Greenhouse Gas Emissions Standards for Heavy-Duty Vehicles: Phase 3

Response to Comments

Assessment and Standards Division
Office of Transportation and Air Quality
U.S. Environmental Protection Agency

Figure 1 FEV High-Level FCEV Packaging Concept³⁹²

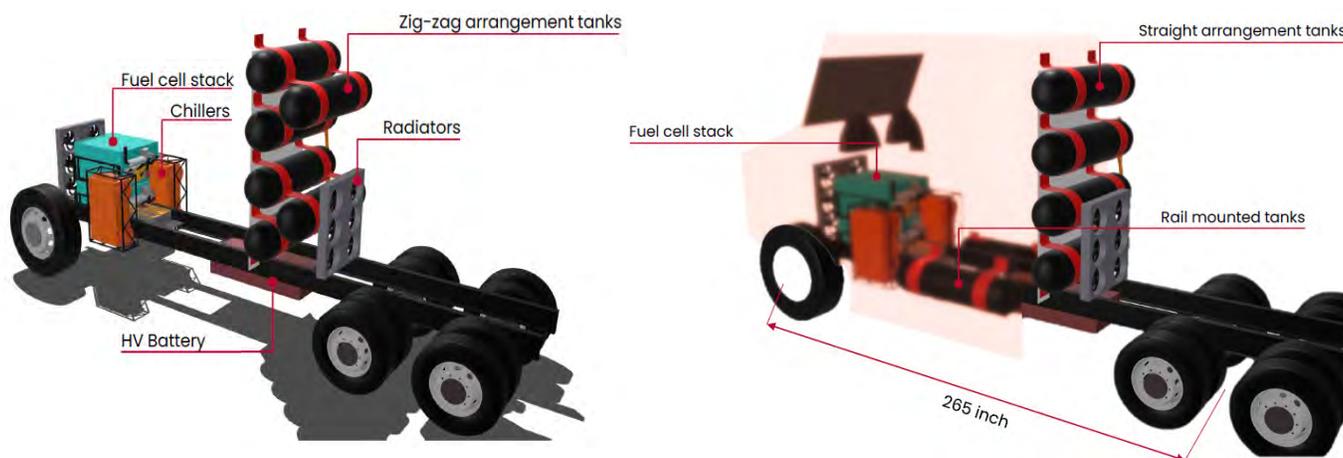
As DTNA suggests, liquid hydrogen technology may prove beneficial in the longer-term. However, gaseous hydrogen is predominantly used today, including for light-duty vehicles, forklifts, and buses. As explained in RIA Chapter 1.7.3, the readiness of liquid storage and refueling technologies is still relatively low compared to compressed gas technologies, so onboard liquid storage tanks are not included as part of the technology package under the modeled potential compliance pathway that supports our rule.

For the final rule, we contracted FEV to independently conduct a packaging analysis for Class 8 long-haul FCEVs that store 700-bar gaseous hydrogen onboard to see if space would be sufficient to accommodate hydrogen fuel for longer-range travel. EPA conducted an external peer review of the final FEV report.³⁹¹ FEV found ways to package six hydrogen tanks (77 kg of hydrogen) to deliver up to a 500-mile range with a sleeper cab using a common 265-inch wheelbase. All of the tanks could be at the back of the cab in a zig-zag arrangement and the batteries inside the frame rails, or four of the tanks could be behind the cab with two tanks mounted to the outside of the frame rails under the cab and the batteries inside the frame rails.

³⁹⁴ Figure 1 shows that a 58 kWh LTO battery could fit between the rails. This means that a 110 kWh LFP battery could also fit between the rails.

Figure 1: Projected U.S. EV Battery Demand and Announced Battery Production Capacity (2022-2032)

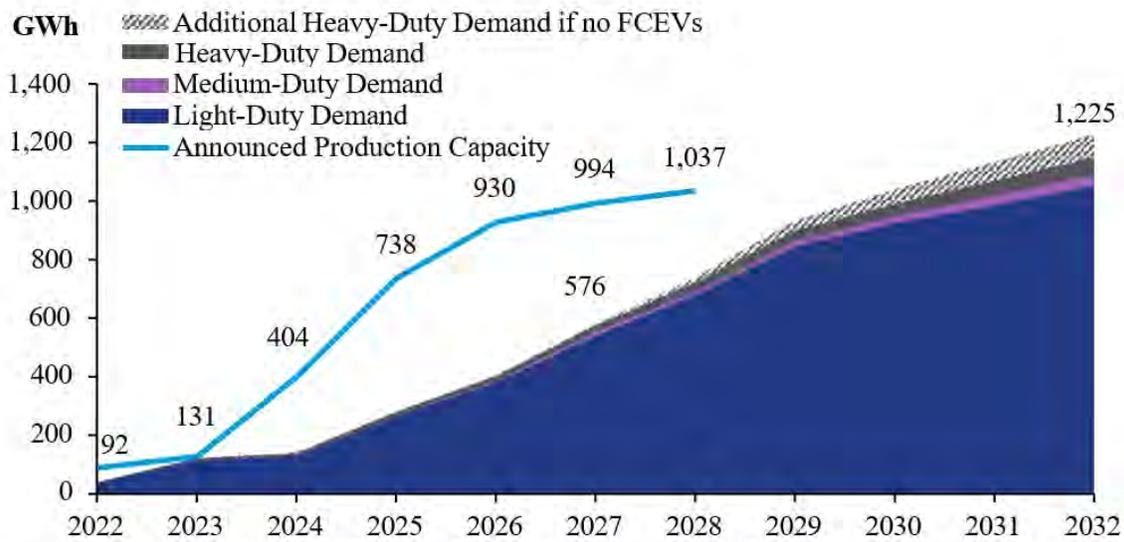
EDF used the EPA’s projections for EV adoption and associated battery demand through 2030.ⁱⁱ Roughly 90% of the potential EV battery demand is from light-duty (passenger) vehicles. Potential demand for batteries in medium-duty vehicles (large pickup trucks and vans) and heavy-duty vehicles (delivery trucks, step vans, semi-trucks, buses, etc.) is much smaller.

Figure 1 shows EPA projected battery demand by segment:
